P802.11wTM/D2.03

Draft Amendment to Standard for Information
Technology - Telecommunications and Information
Exchange Between Systems information exchange
between systems - LAN/MAN Specific Requirements Local and metropolitan area networks Specific requirements -

Part 11: Wireless LAN Medium Access Control (MAC) and Physical Layer (PHY) specifications:

Amendment <<u>number></u>5 : Protected Management Frames

Figure 5-13—Establishing pairwise and group keys

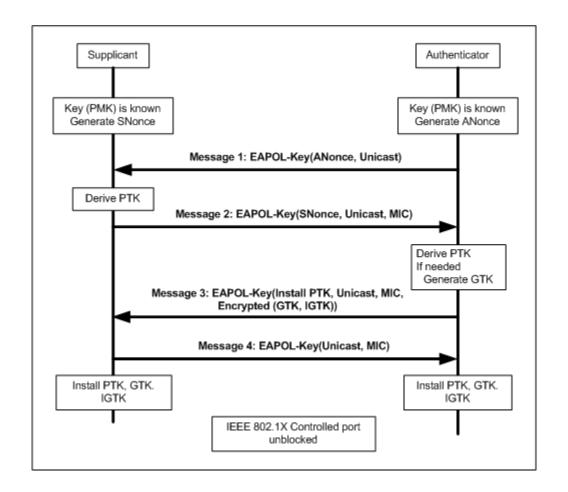
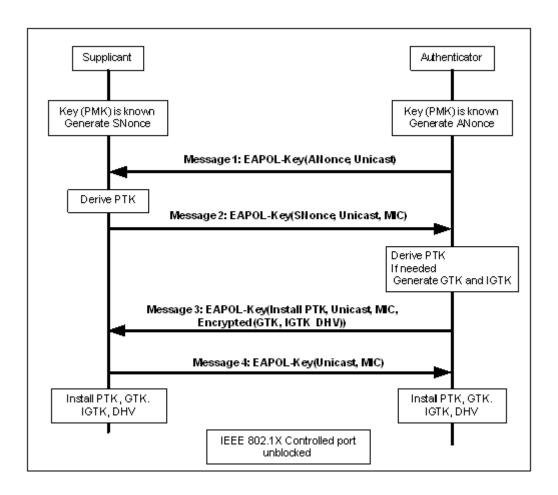
Replace Figure 5-13 with the following figure, with the changes being the inclusion of "IGTK" in message 3 and in both the Supplicant and Authenticator boxes that begin with "Install" and in the Authenticator box to "Generate GTK and IGTK":

Figure 5-14 — Delivery of subsequent group keys

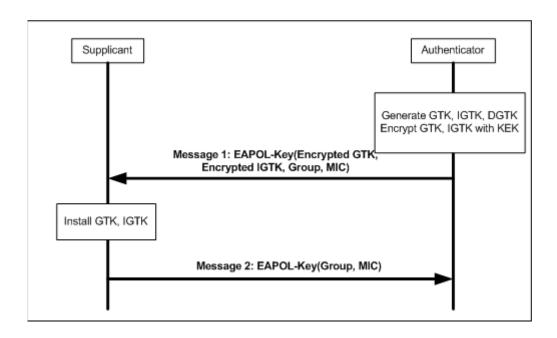
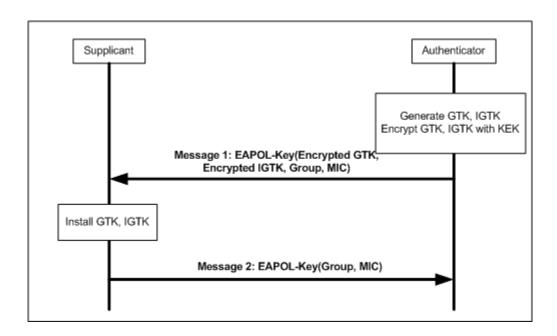
Replace Figure 5-14 with the following figure, with the changes being the inclusion of "Encrypted IGTK" in Message 1, "IGTK" in the Authenticator box beginning with 'Generate" and "IGTK" in the Supplicant box beginning with "Install"; the update to the 2nd box on the right has intentially intentionally fixed from the 802. Ima D9.0 draft 11-2007 to correctly state "Encrypt GTK, IGTK with KEK":

Figure 8-18 — Nonce Construction

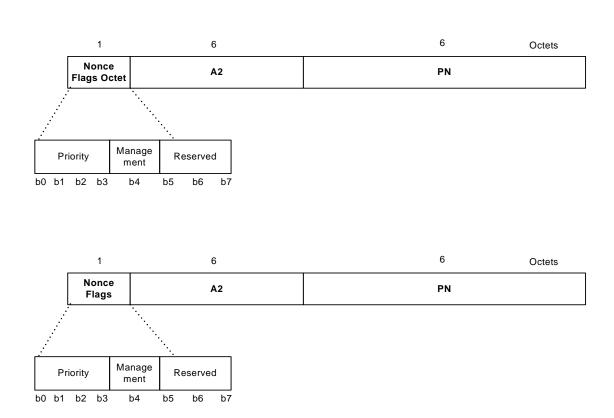
Replace Figure 136-8-18 with the following figure "replacing "Priority Octet" with "Nonce Flag Octet", and addition of "Management" as bit 4 of this octet.":

EDITORIAL NOTE: ANA must be requested for this bit (4). There has have been issues editing the above Figure and thus is left as B4....readers should note that until ANA assigns this bit, it should read TBD <ANA >, pending ANA assignment.

Figure 8-33—Sample 4-Way Handshake

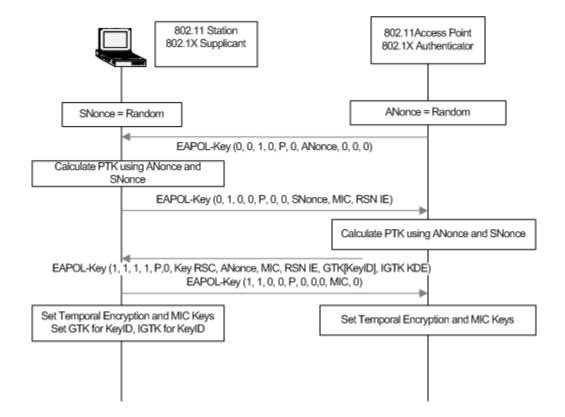
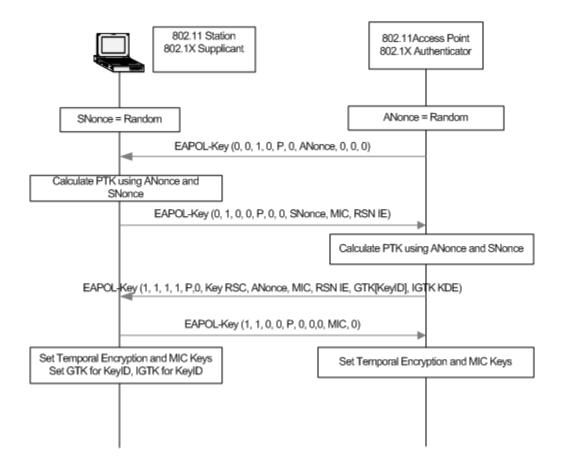
Replace Figure 151 with the following Figure, with the updated updates including IGTK KDE on the 3rd EAPOL-Key message and "IGTK for Key ID" on the 3rd supplicant box:

Figure 8-34—Sample Group Key Handshake

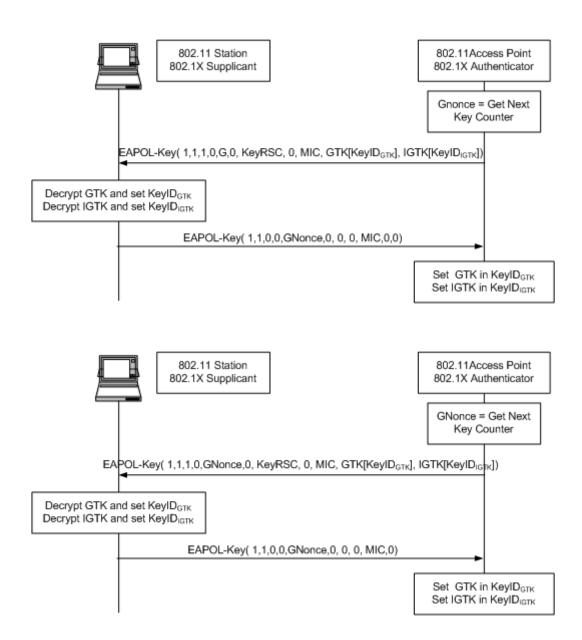
Replace Figure 152-8-34 with the following Figure, with the updated updates including IGTK on the first EAPOL-Key message and 2nd supplicant box, adding "0,0" on reformatting the first message above the second EAPOL-Key message arrow and IGTK and new subscripts to the last Authenticator box:

Figure 8-35—RSNA Supplicant key management state machine

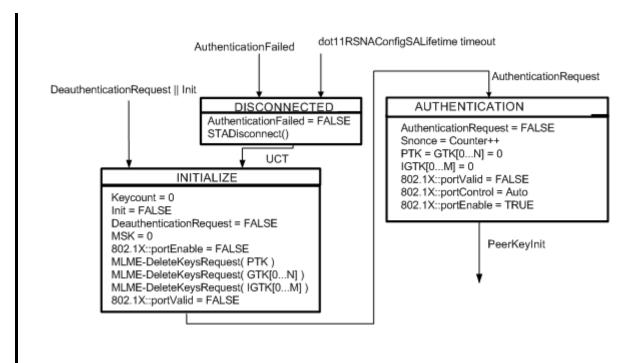
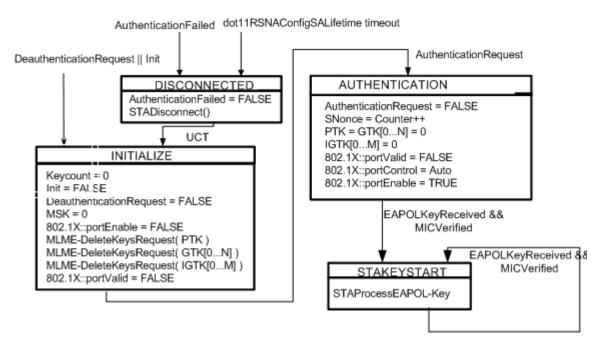
Replace Figure 153—8-35 with the following figure updating "Snonce" to "SNonce", adding "IGTK[0...NM] = 0" in the "AUTHENTICATION" box and "MLME-DeleteKeysRequest(IGTK[0...NM])" to the "INITIALIZE" box:

Figure 8-37—Authenticator state machines, part 1

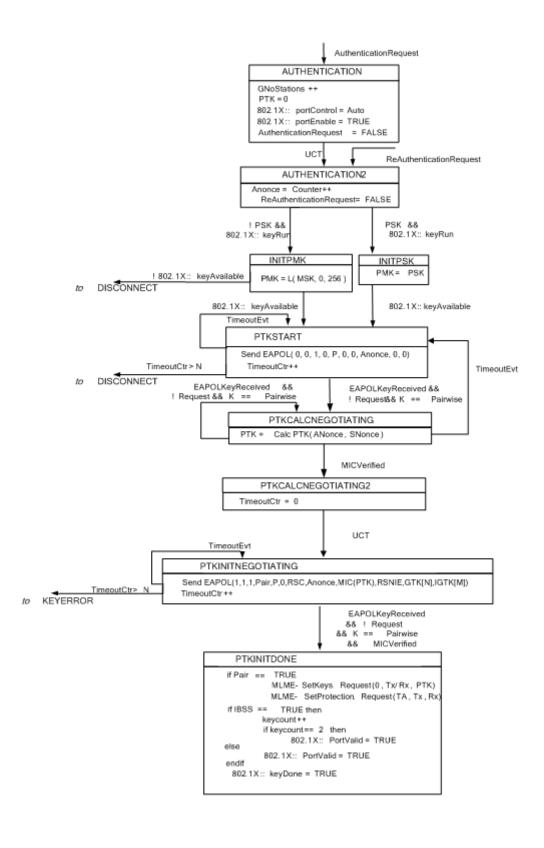
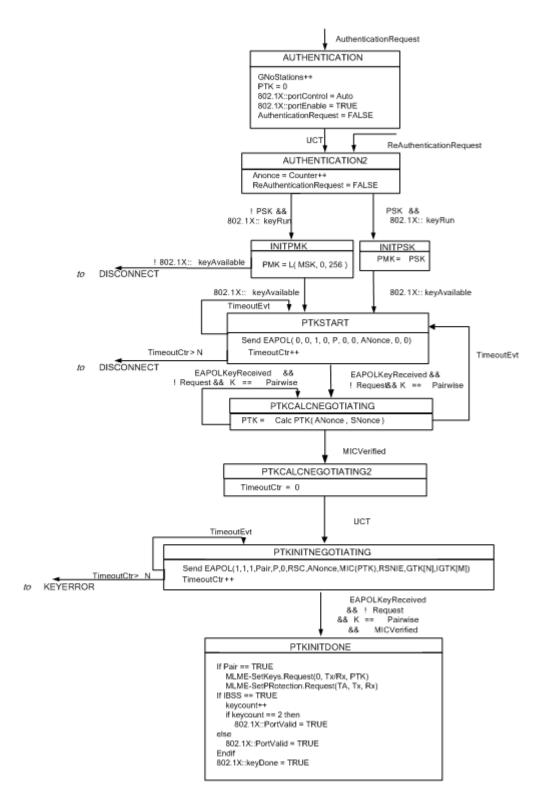
Replace Figure 155-8-37 with the following Figure, with the updates being fixing Anonce with ANonce in the PTKSTART, PTKCALCNEGOTIATING, and PTKINITNEGOTIATING and the insertion of "IGTK[M]" in the PTKINITNEGOTIATING box:

Figure 8-40—Authenticator state machines, part 44

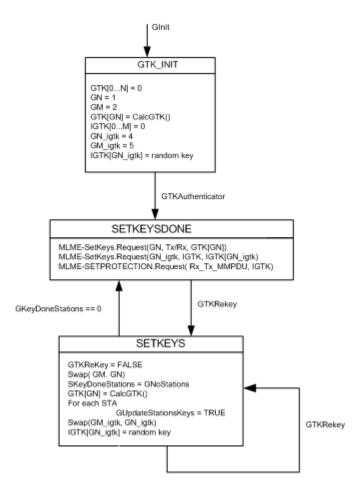
Replace Figure 8-40 with the following Figure, with the updates being the addition into the GTK_INIT state (semicolons showing linebreaks): "IGTK[0..M] = 0; GN_igtk = 4; GM_igtk = 5; IGTK[GN_igtk] = random key"; addition into SETKEYSDONE state: "MLME-SETKEYS.request(GN_igtk, IGTK, IGTK[GN_igtk]); MLME-SETPROTECTION.request(Rx_Tx_MMPDU, IGTK)". Addition into SET-KEYS state: "Swap(GM_igtk, GN_igtk); IGTK[GN_igtk] = random key".insertion of "IGTK[M]" in the PTKINITNEGOTIATING box:

Figure 11A-13—Authenticator R1KH state machine (part 1)

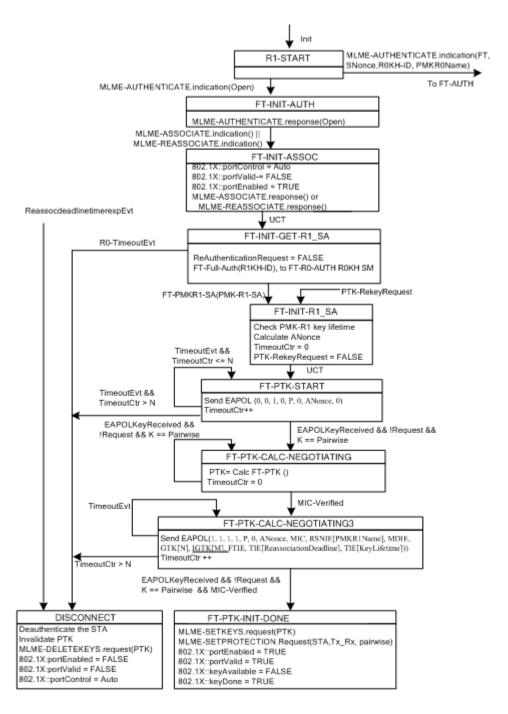
Replace Figure 11A-13 with the following Figure, with the updates being including "IGTK[M]" in the FT-PTK-CALC-NEGOTIATING3 box:

Figure 11A-14—Authenticator R1KH state machine (part 2)

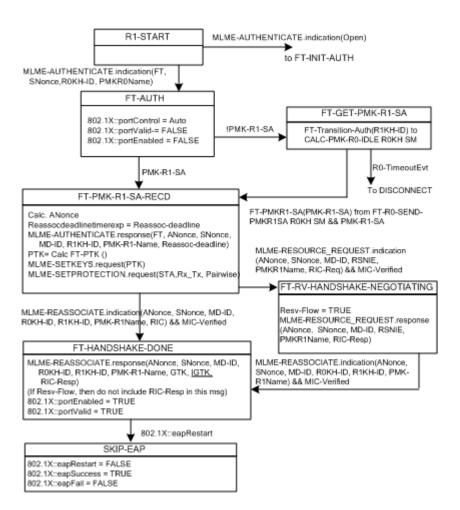
Replace Figure 11A-14 with the following Figure, with the updates being including "IGTK" in the FT-HANDSHAKE-DONE box:
